SCOPE OF PROJECT CHANGES:

PERMIT DRAWINGS

CLARKSON RESIDENCE

NO.	DESCRIPTION	DATE
3	PERMIT REVISION	04.19.22
4	PERMIT REVISION CORRECTIONS	06.10.22

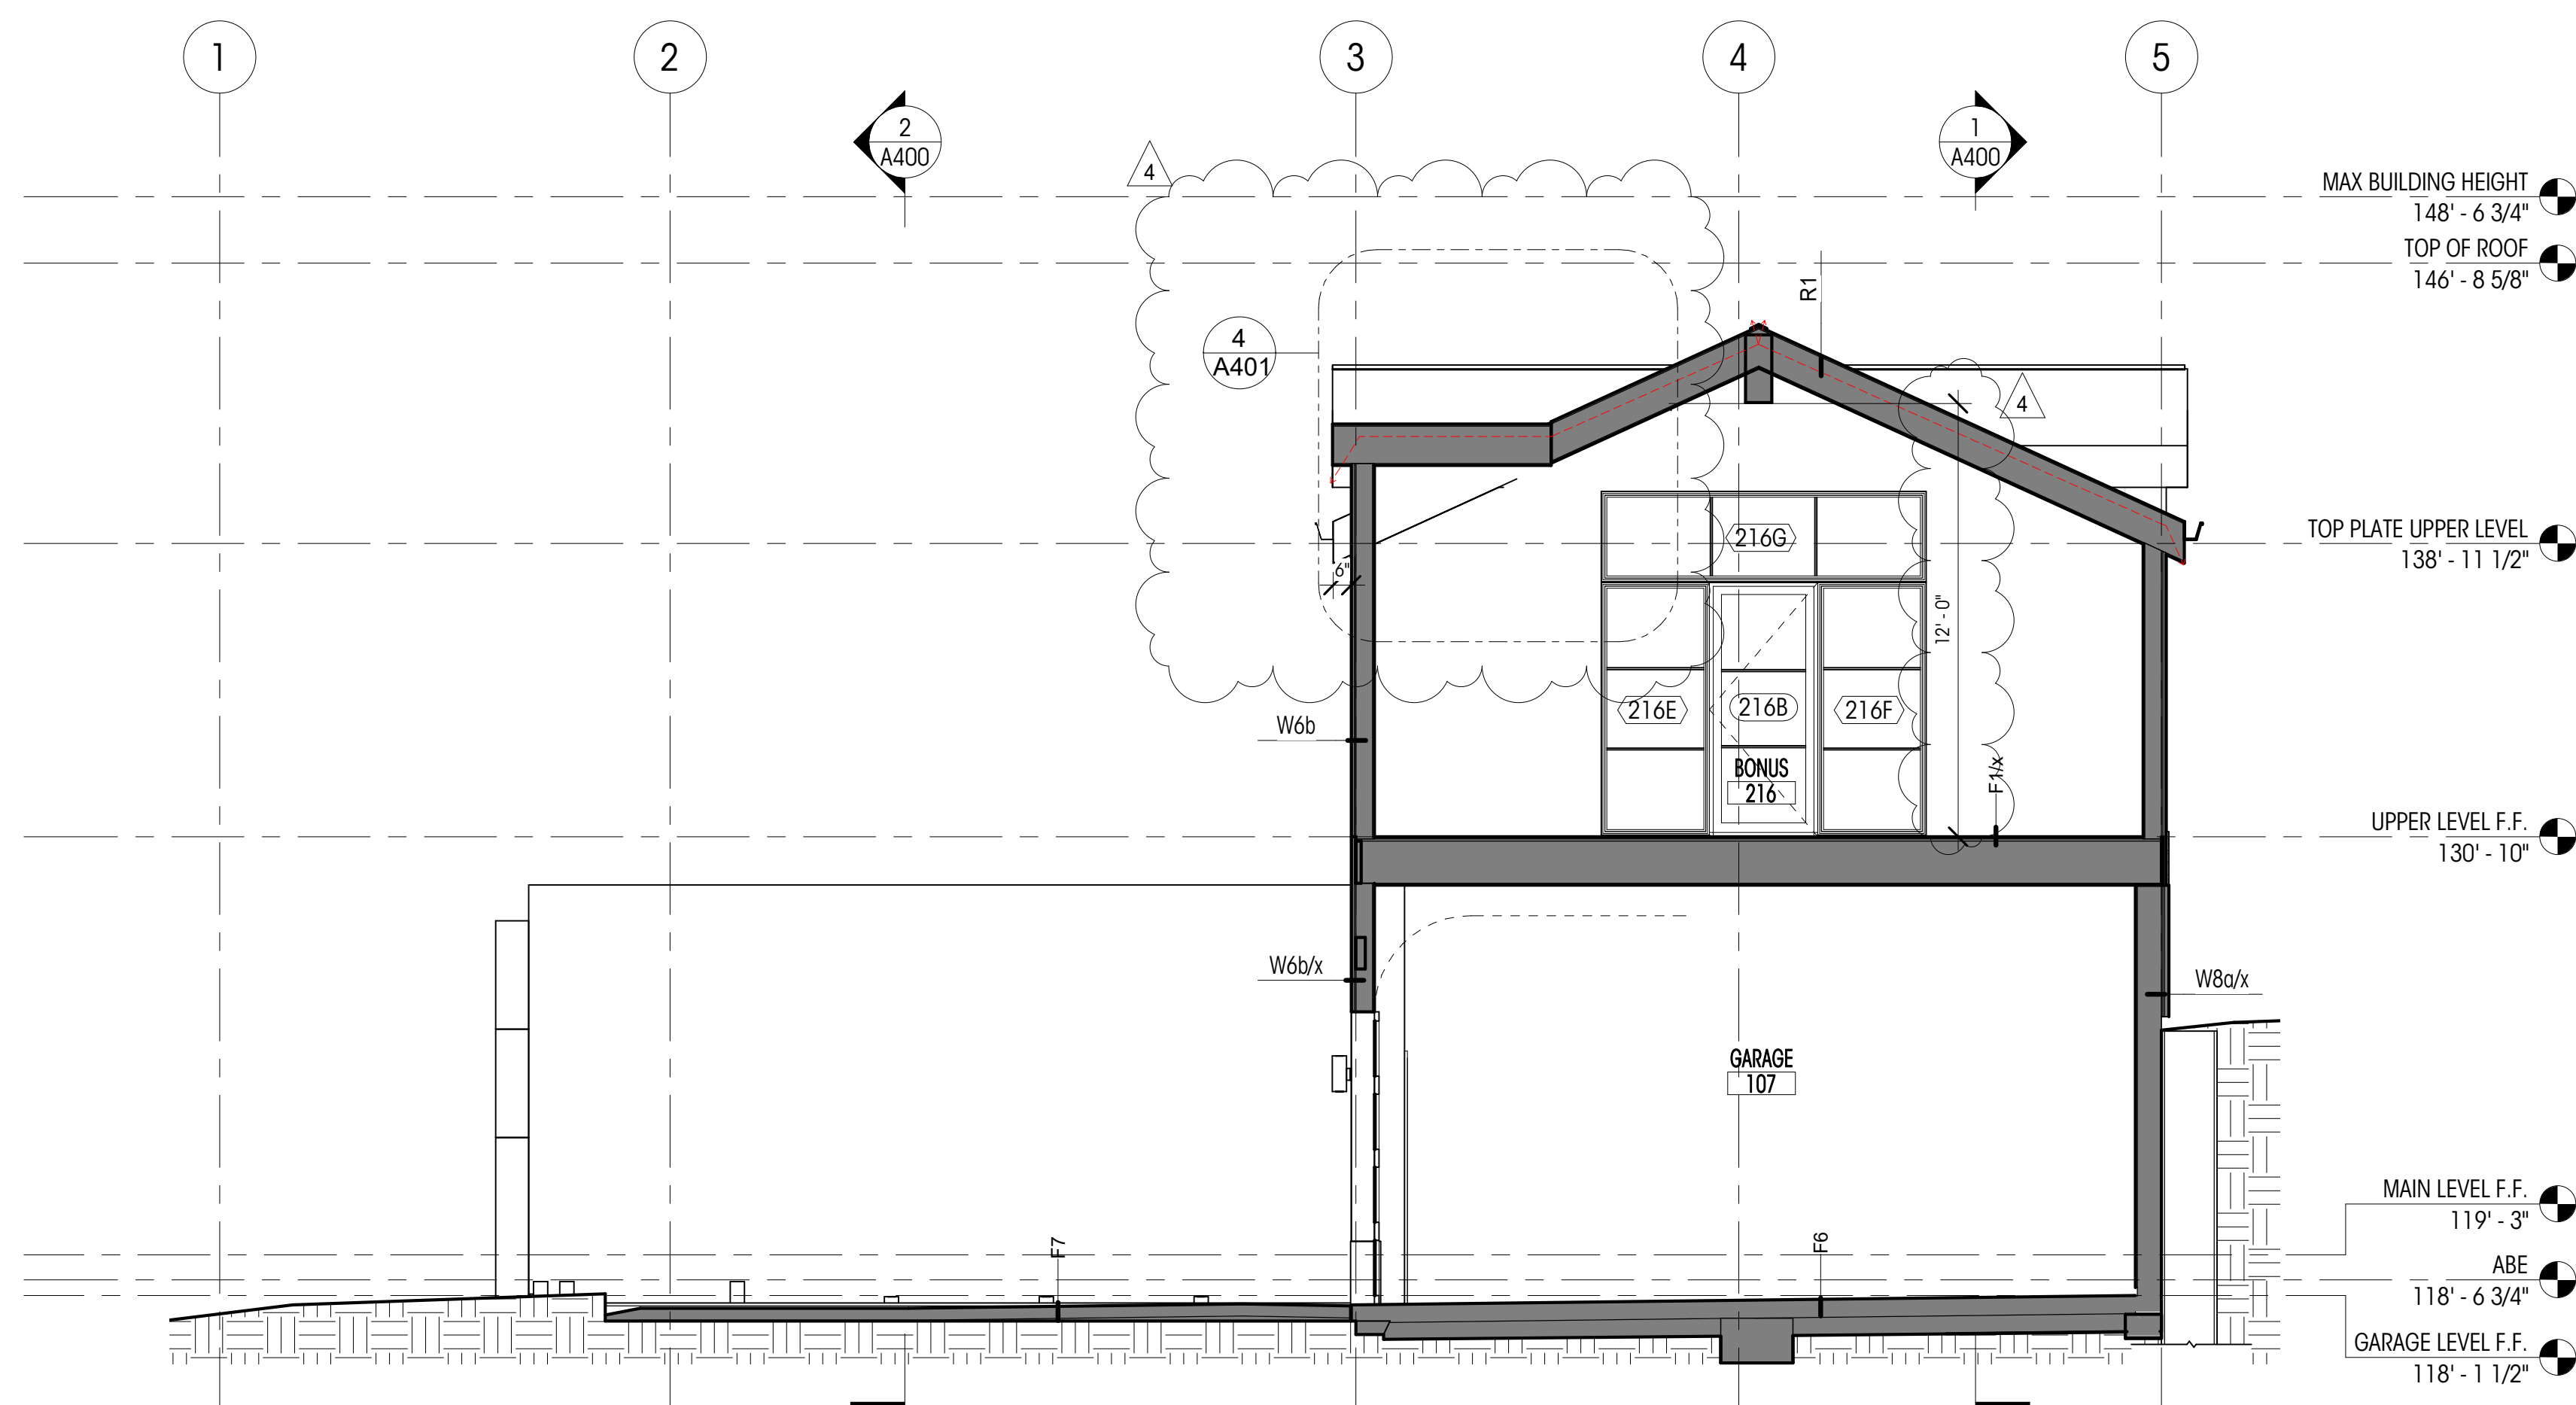
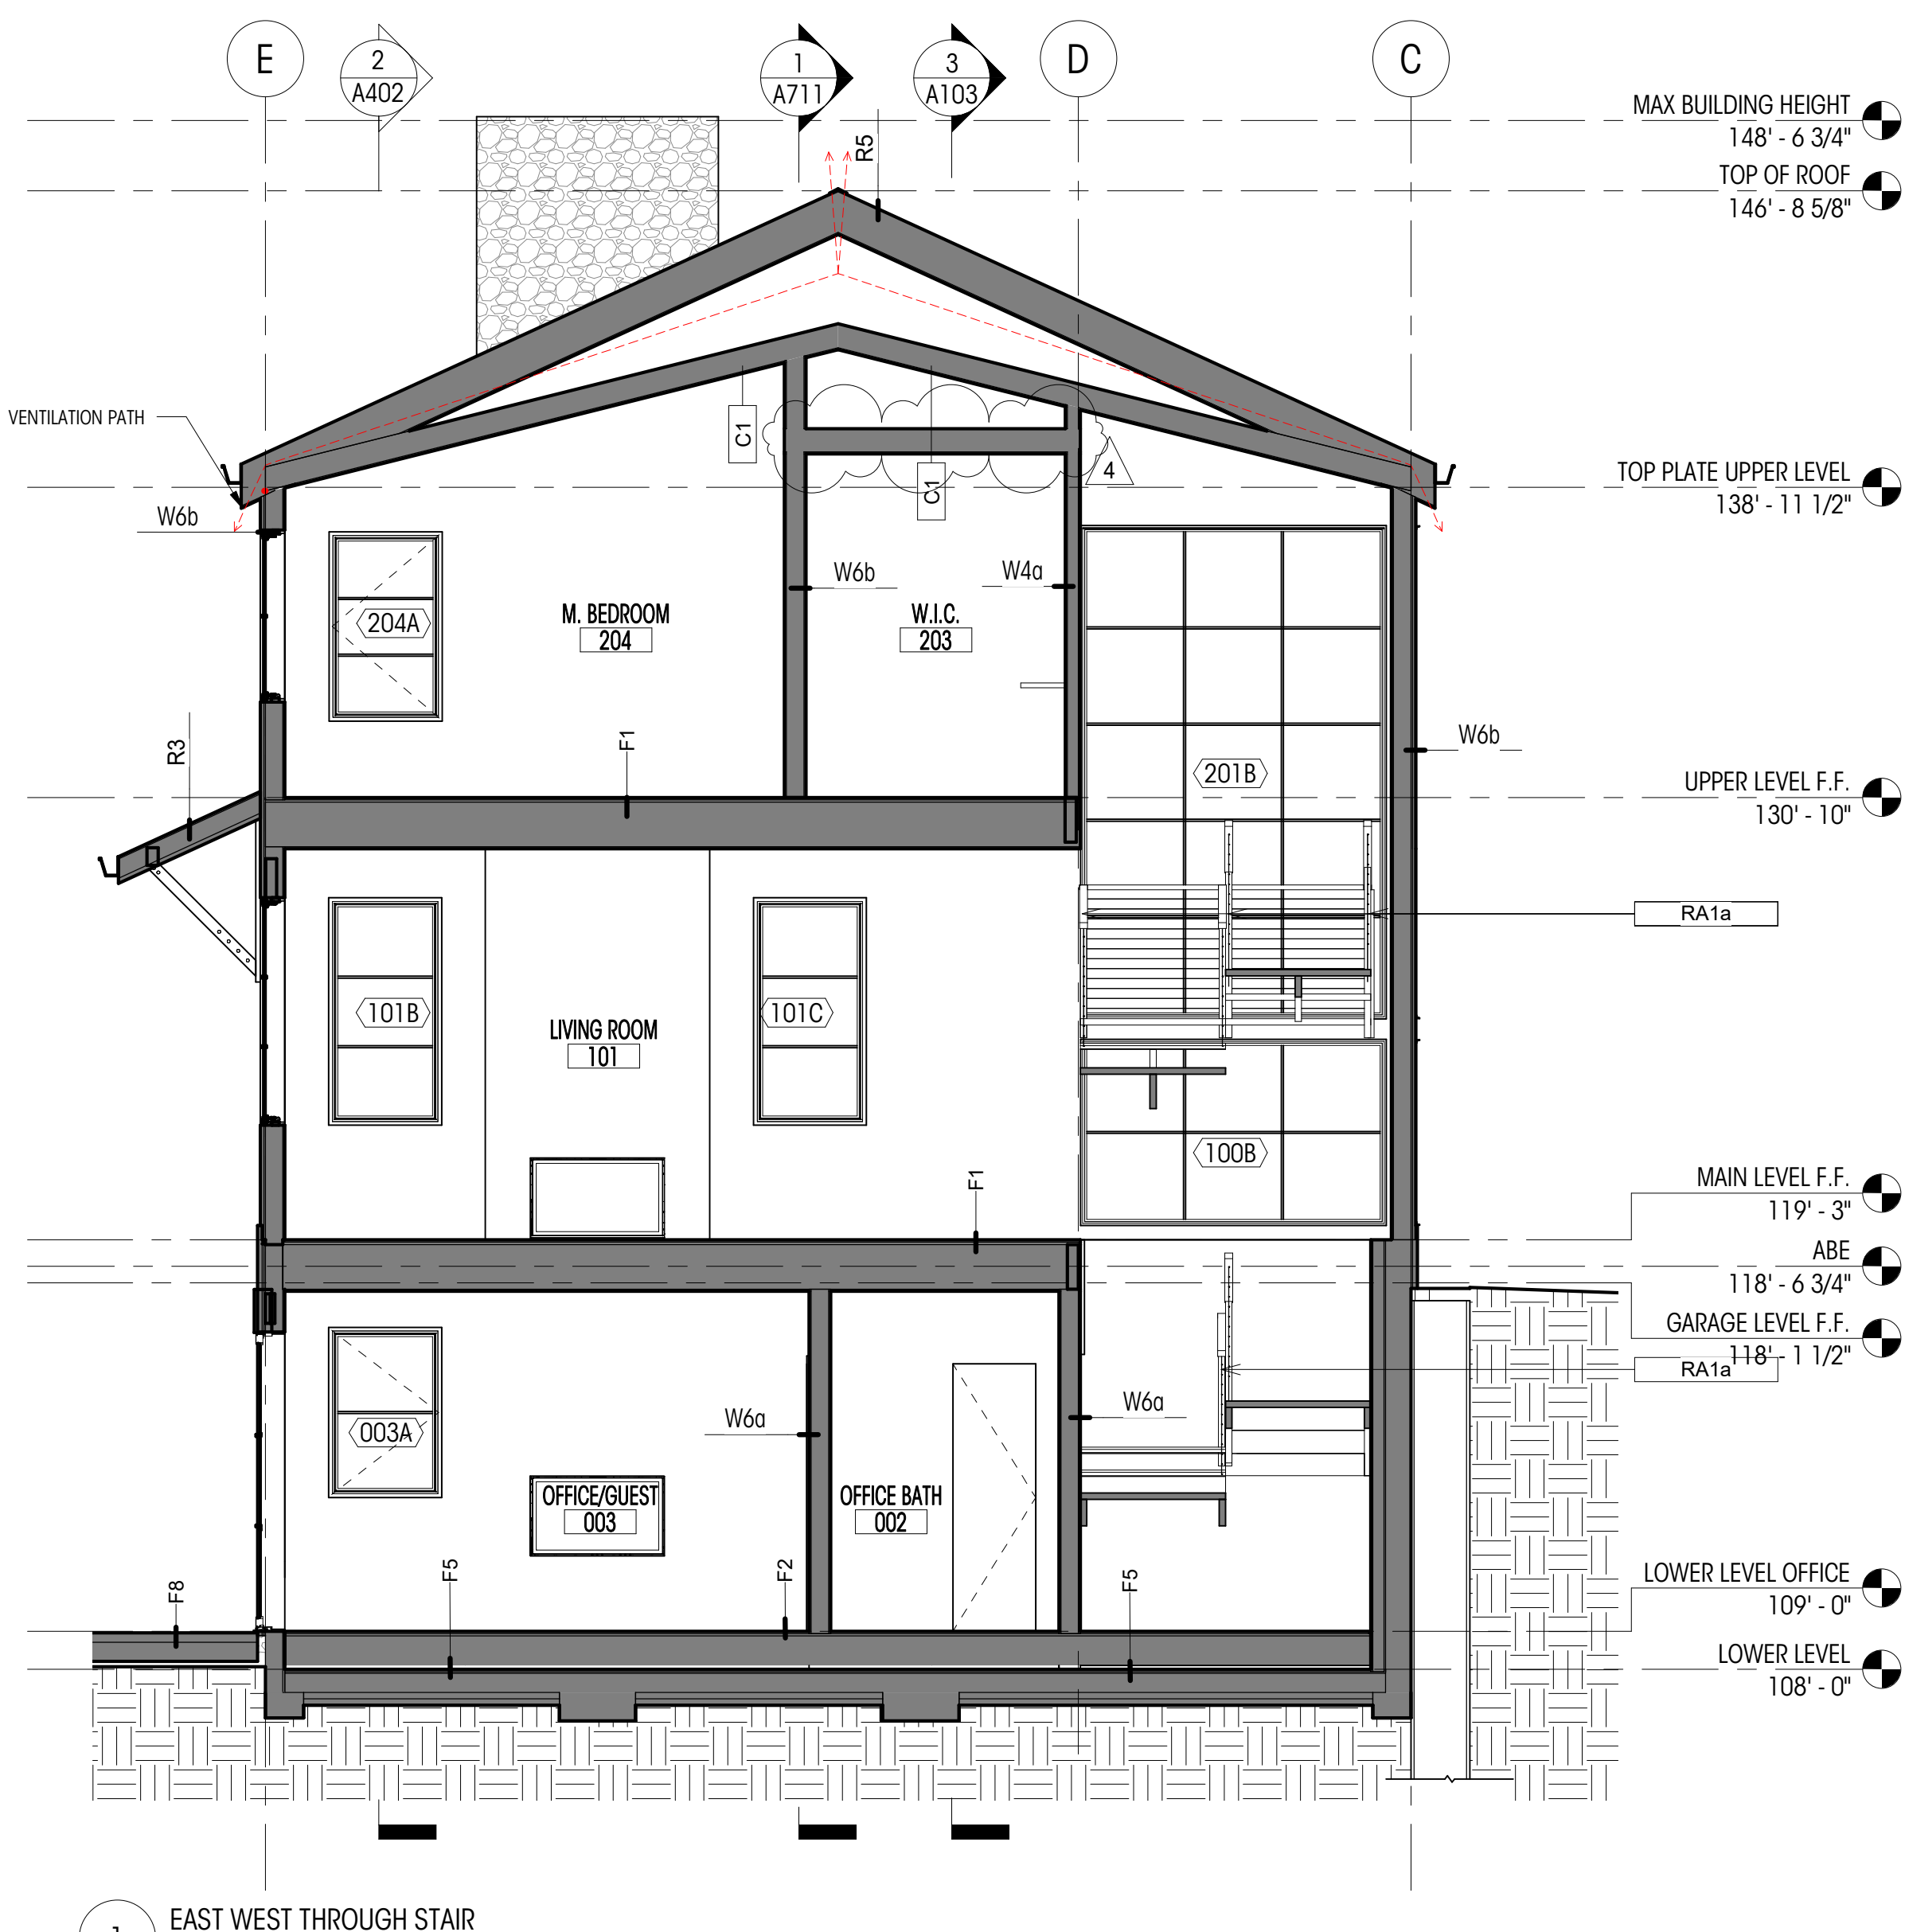
- REVISION SCOPE OF CHANGES:**
- VIEW NUMBERING UPDATED AND ADJUSTED FOR CLARIFICATION
 - CHANGE ROOF OF AND EXTEND WESTERN PATIO TO THE WEST AND SOUTH
 - LEVEL CHANGES: DRIVEWAY & GARAGE LEVEL DROP BY 12"; BASEMENT LEVEL DROP BY 12"

- ENTRY DESIGN CHANGE
 - ADDED DORMERS AT UPPER LEVEL BONUS ROOM
 - EXTEND GARAGE EAST INTO FRONT YARD SETBACK AS ALLOWED BY CODE 19.02.040.D
 - SHEET LAYOUT ADJUSTED FOR ORGANIZATIONAL PURPOSES

- "VIEW 1" WAS MOVED FROM SHEET A400 AND STAYED "VIEW 1"
 - LEVEL CHANGES:
 - a. DRIVEWAY & GARAGE LEVEL DROP BY 15"
 - b. BASEMENT LEVEL DROP BY 12"
 - c. UPPER LEVEL DROP BY 2"

- d. FRAMED FLOOR 12" ABOVE BASEMENT FLOOR
 - e. CHANGE TO ABE AS A RESULT OF EXTENDED GARAGE AND EXTENDED COVERED DECK
 - f. CHANGE TO MAX HEIGHT AS A RESULT OF THE ADJUSTMENT TO THE ABE.

- g. TOP PLATE LEVEL ADJUSTED UP BASED ON ROOF FRAMING
 - h. TOP OF ROOF HAS LOWERED AS A RESULT OF REDUCED ROOF PITCH
